**WEST HAYMARKET PARKING DECK NO. 1
Deck 1 GMP Set
ADDENDUM NO. 3**

PROJECT: West Haymarket Joint Public Agency
Lincoln Haymarket Infrastructure Team
Parking Deck No. 1
Lincoln, Nebraska

AD-3

DATE ISSUED: Tuesday, August 21, 2012

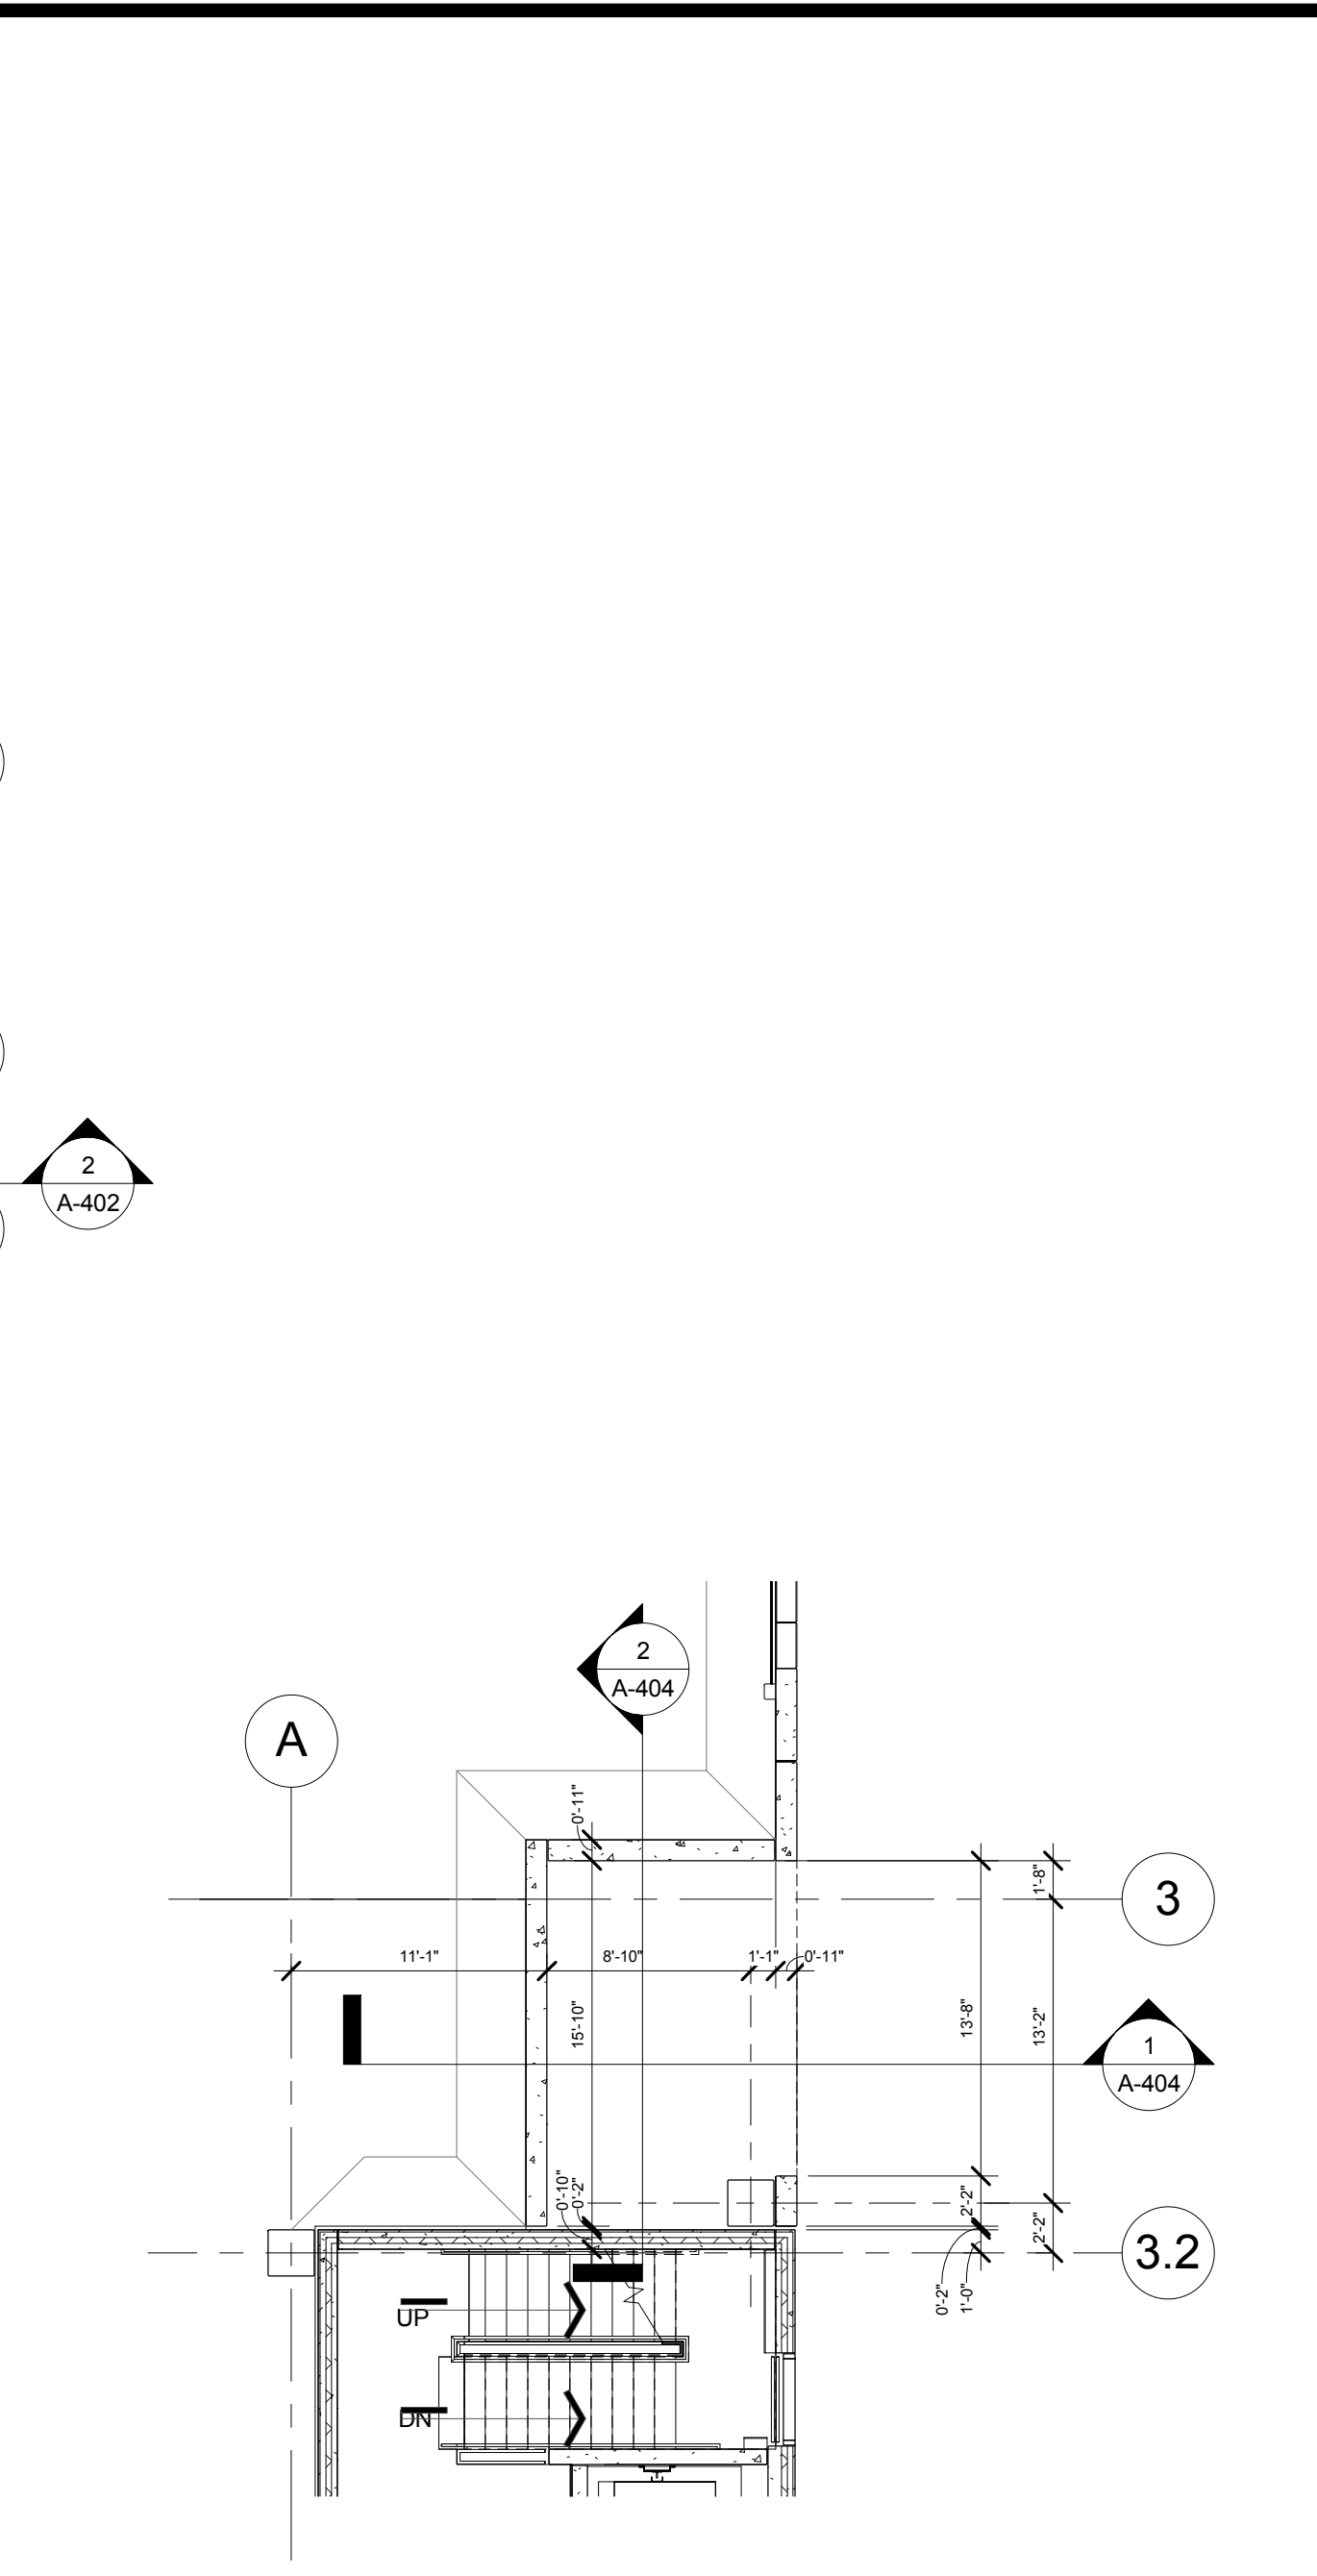
In reference to sheet U-101, revise Mechanical Site Keyed Notes per attached Supplemental Drawing U-101.1. Connection of water service to City water main shall be with sleeve and valve.

- ① CONNECT 12" STORM DRAIN PIPING TO 12" STORM SEWER STUBBED OUT FROM CURB INLET. FIELD VERIFY EXACT LOCATION OF 12" STORM SEWER.
- ② CONNECT NEW 2" DOMESTIC WATER SERVICE TO 12" WATER MAIN. WATER MAIN SLEEVE AND VALVE WITH VALVE BOX BY LINCOLN WATER SYSTEM, SERVICE BY PLUMBING CONTRACTOR. MAINTAIN MINIMUM 36" HORIZONTAL CLEARANCE FROM SANITARY SEWER AND BUILDING DRAIN.
- ③ CONNECT NEW 4" SANITARY SEWER AND BUILDING DRAIN TO 6" SANITARY SEWER STUBBED OUT. MAINTAIN 36" MINIMUM HORIZONTAL CLEARANCE FROM DOMESTIC WATER SERVICE.

SHEET NUMBER
A-101

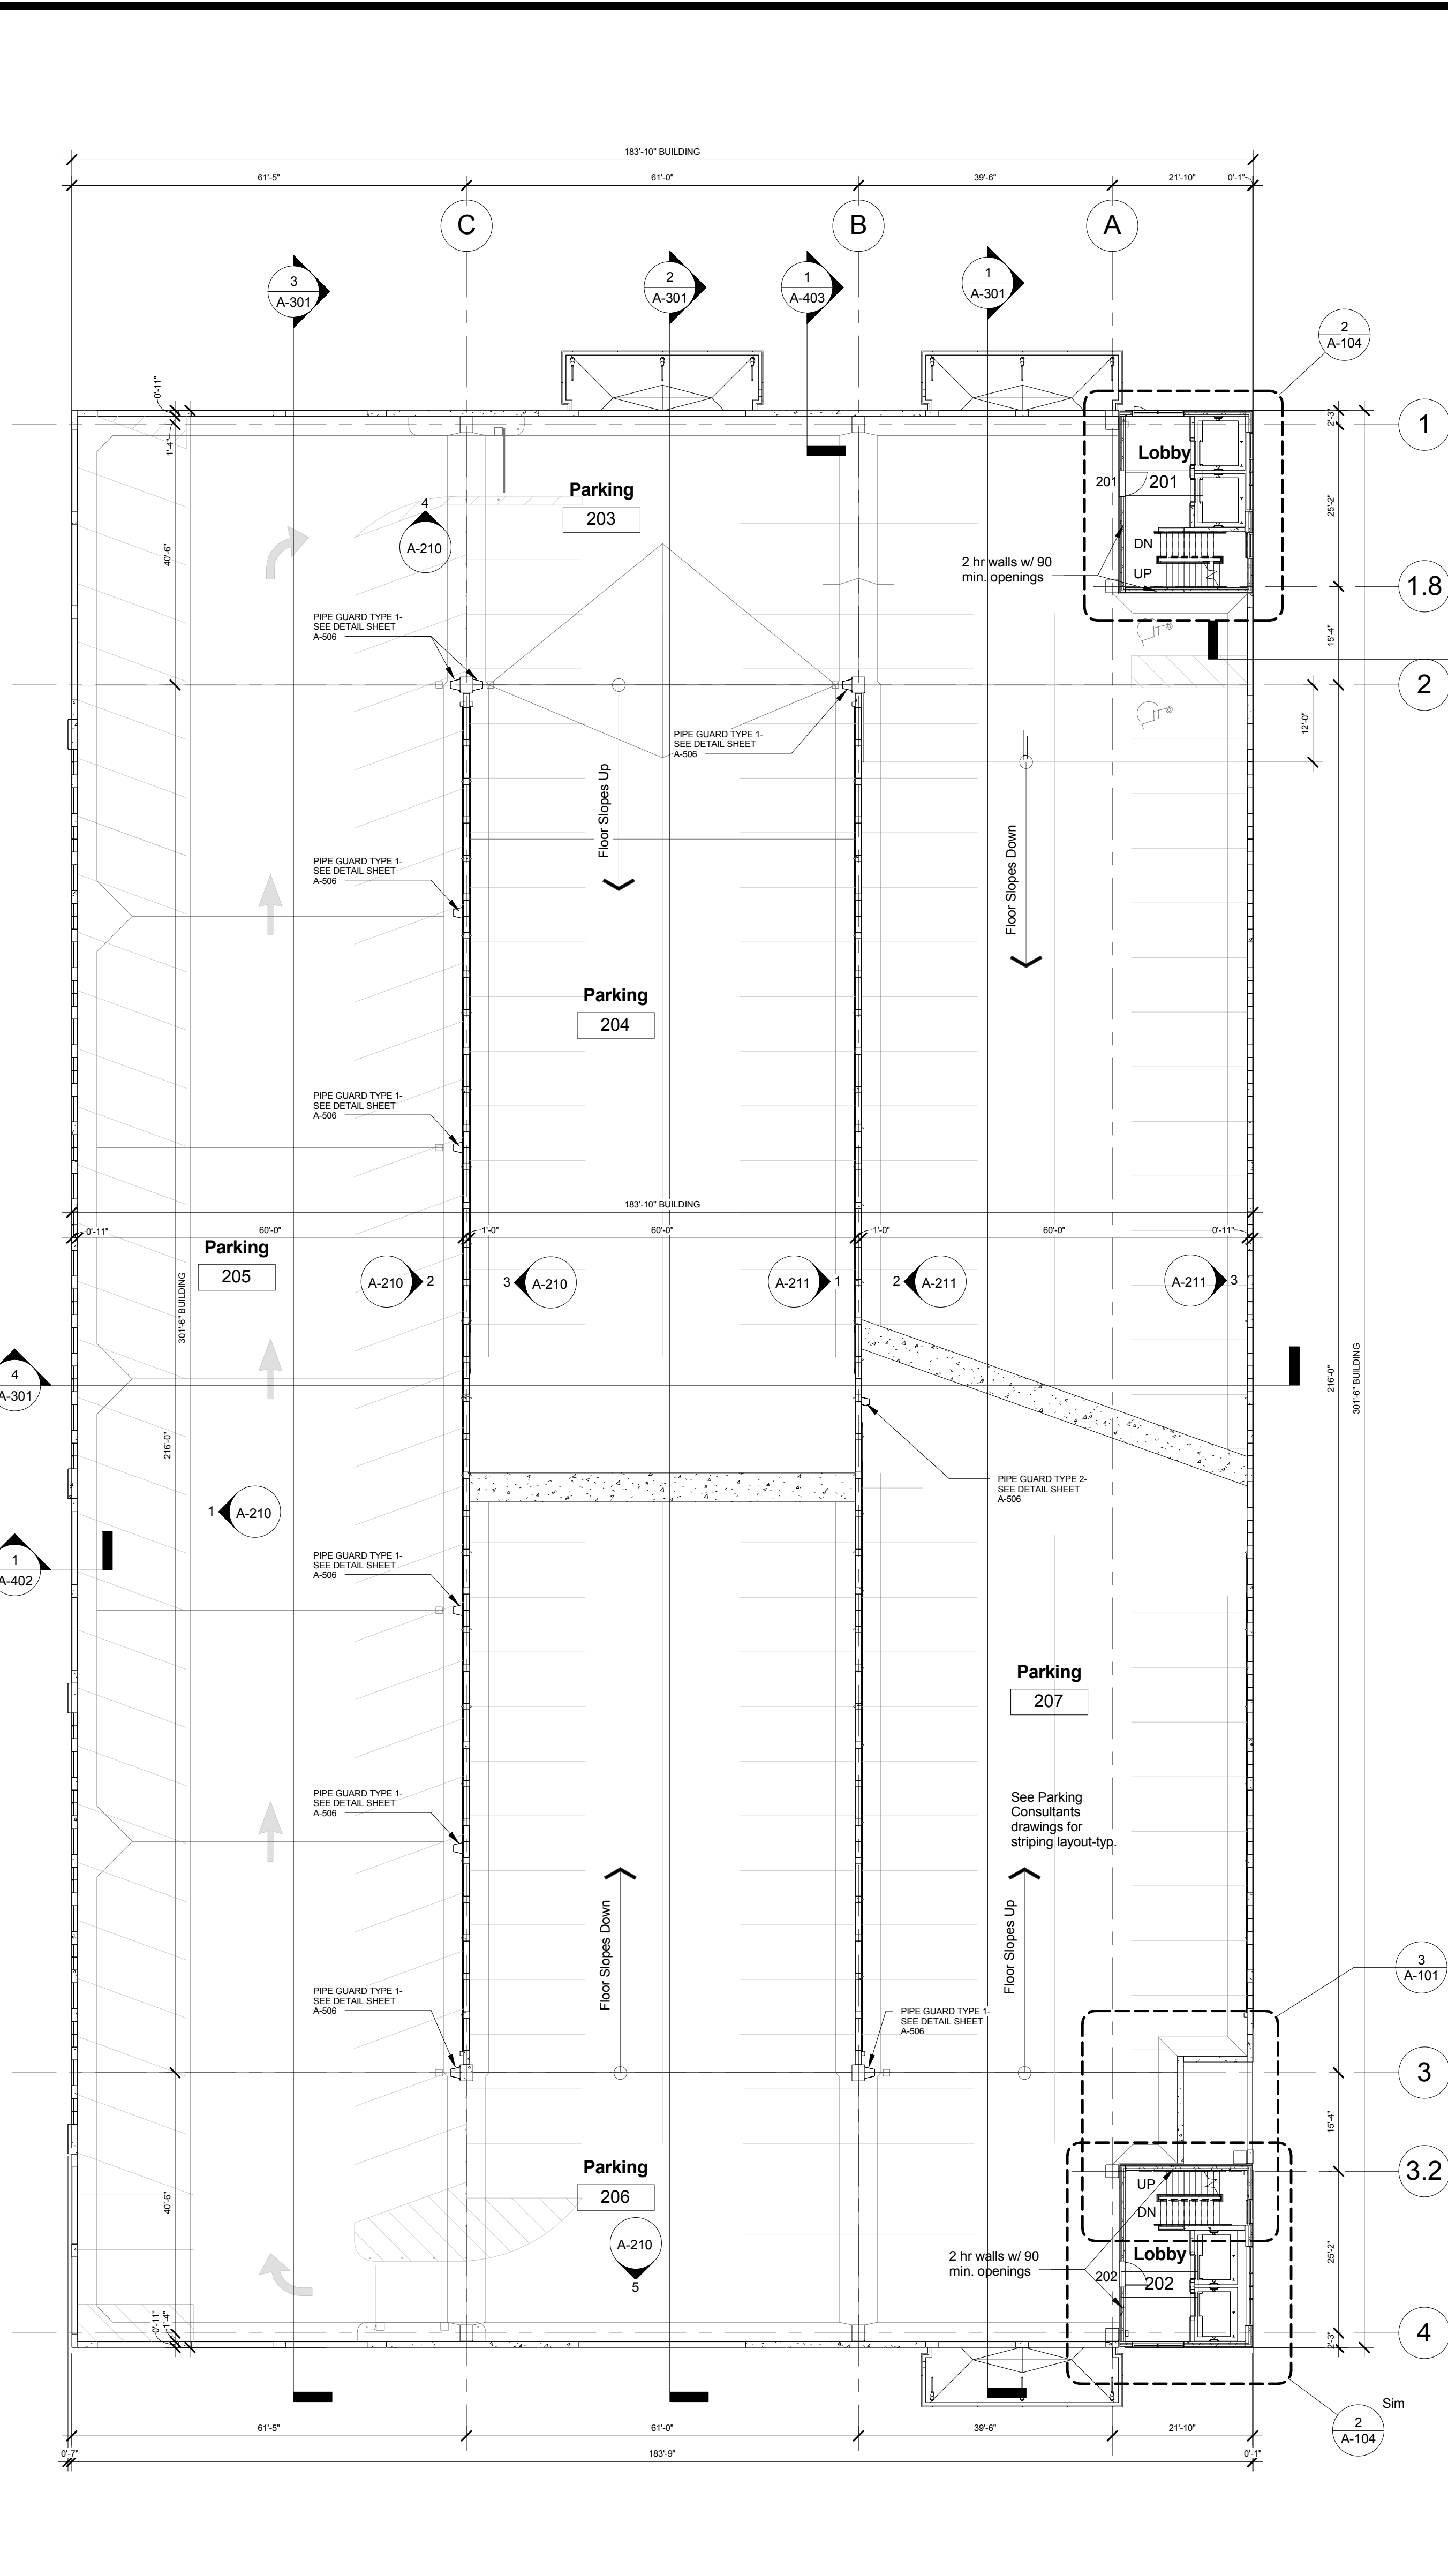
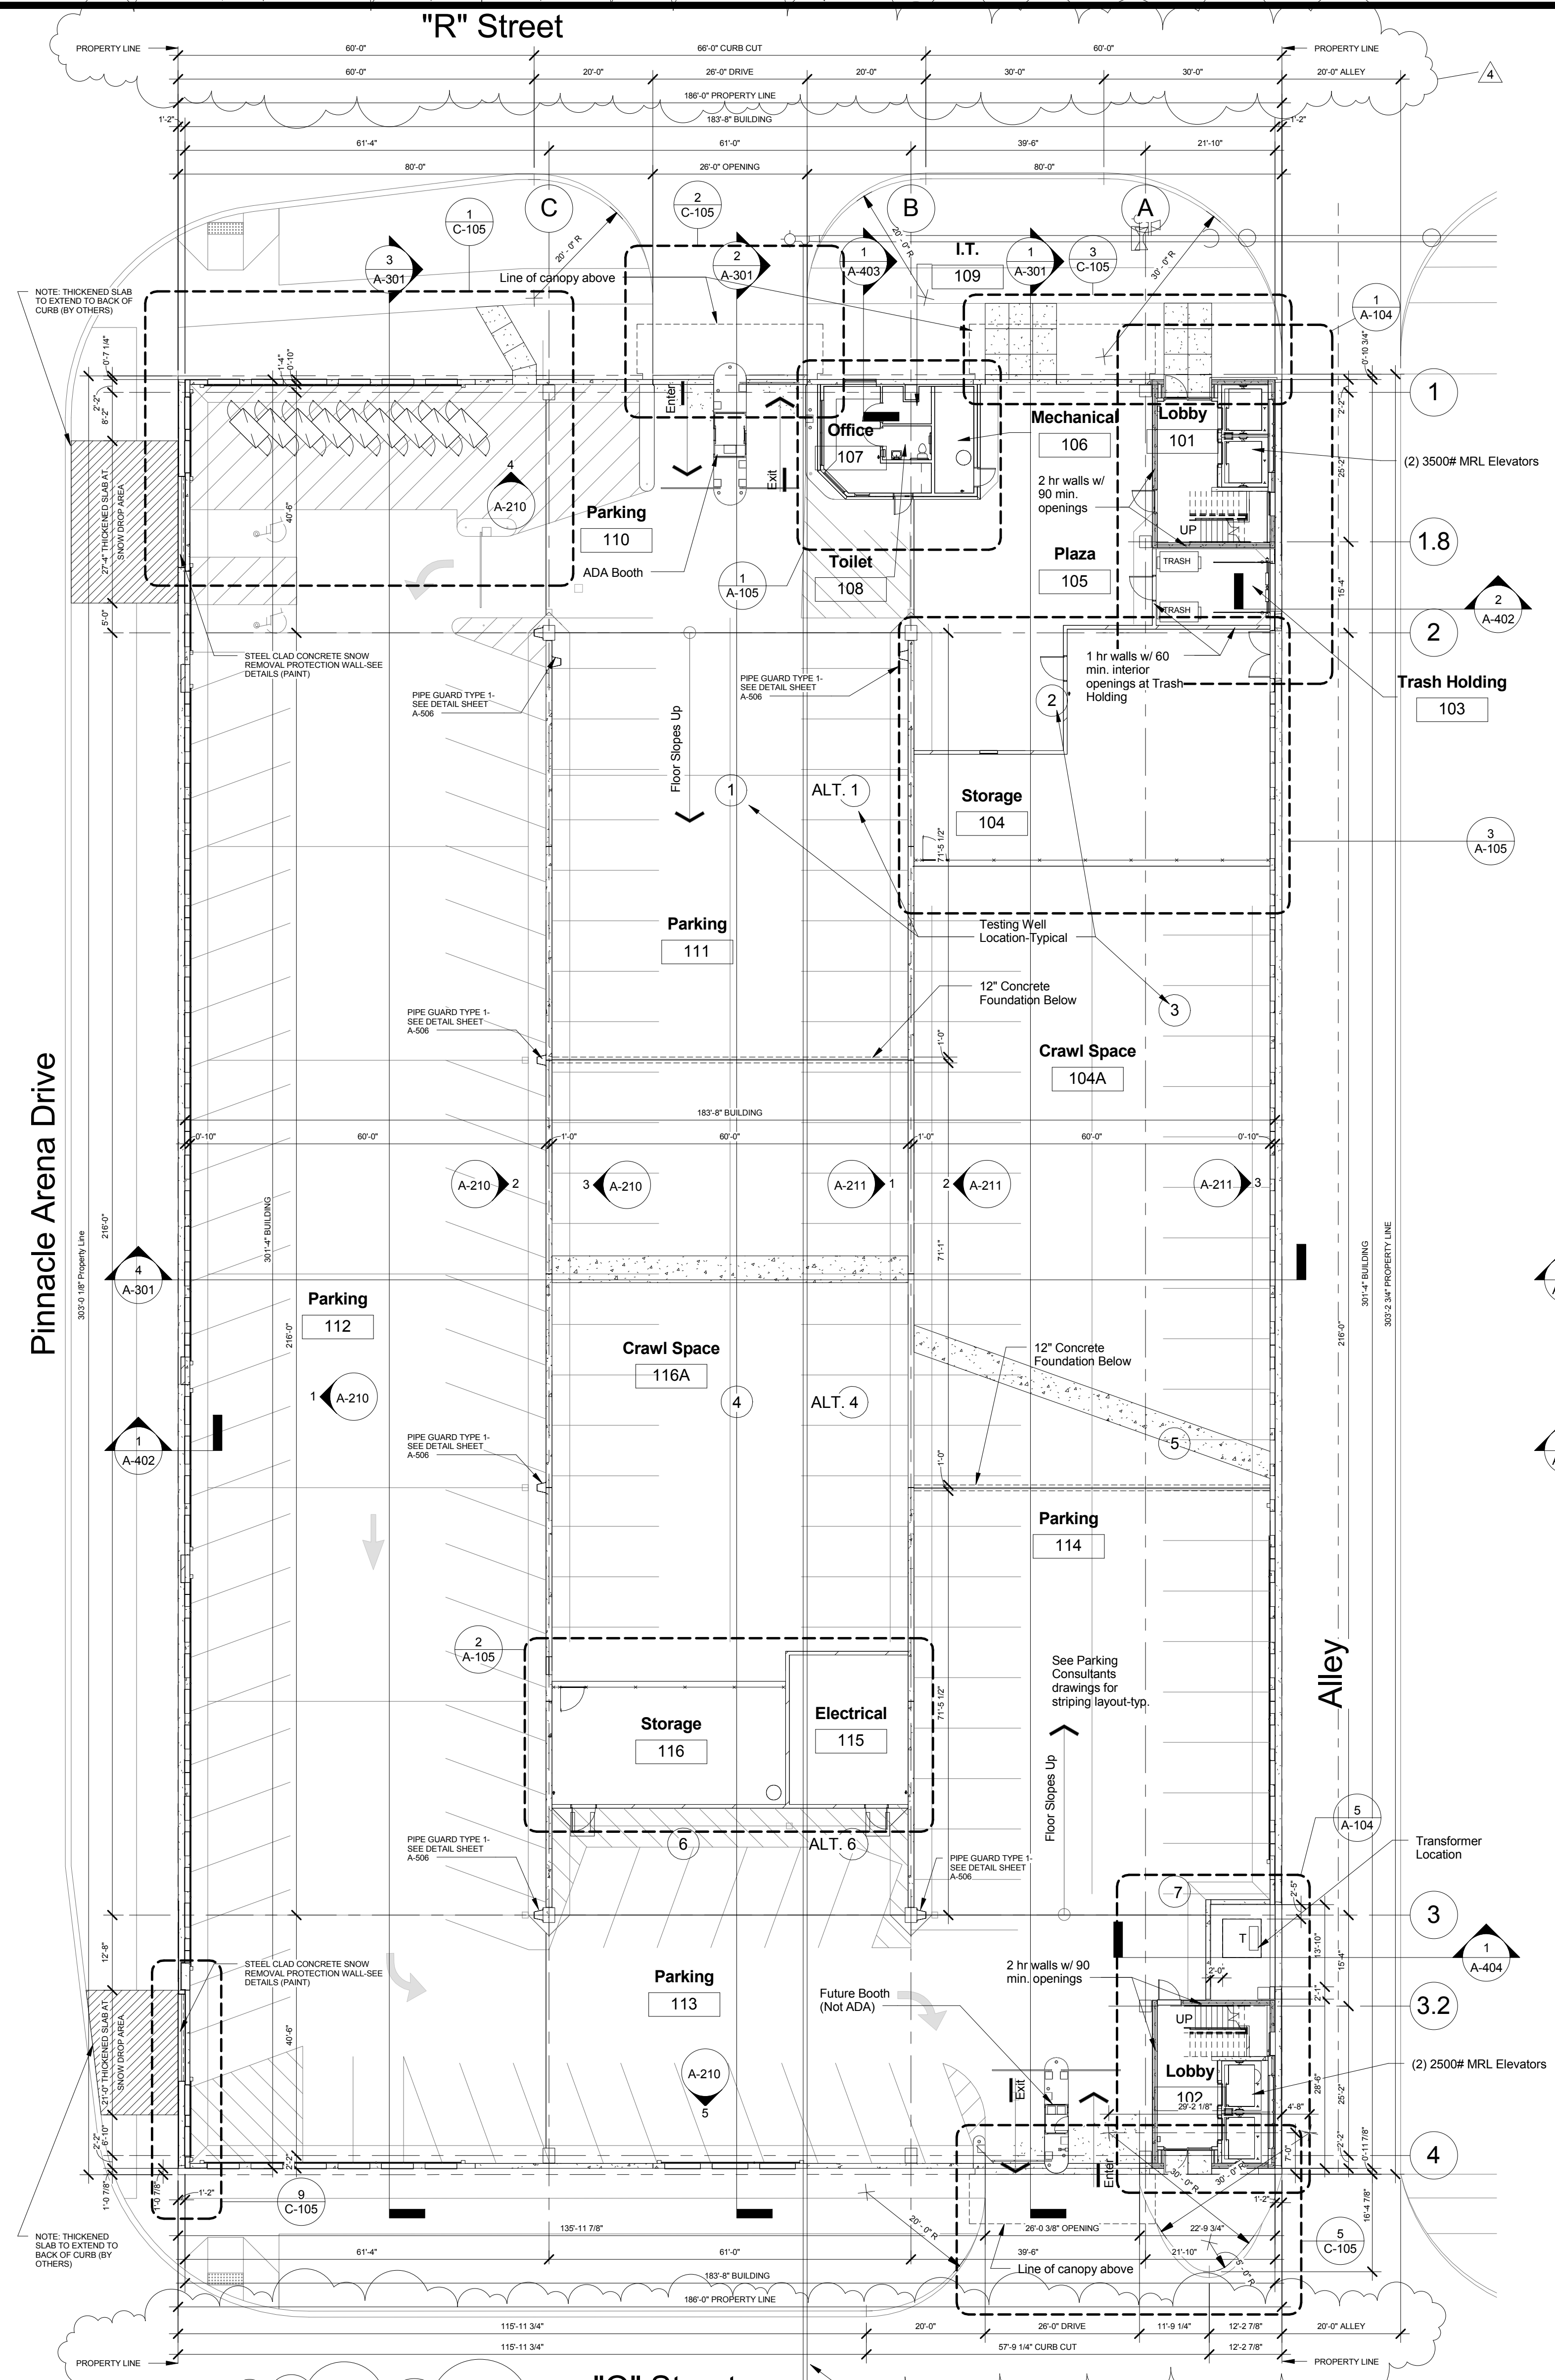
In reference to Sheet A-101, revise Level 1 Floor Plan to indicate proposed driveway dimensions, dimensions of the driveway radii and dimensions of driveways to lot corners on the site and as indicated per attached Supplemental Drawing A-101 revised 08/14/2012.
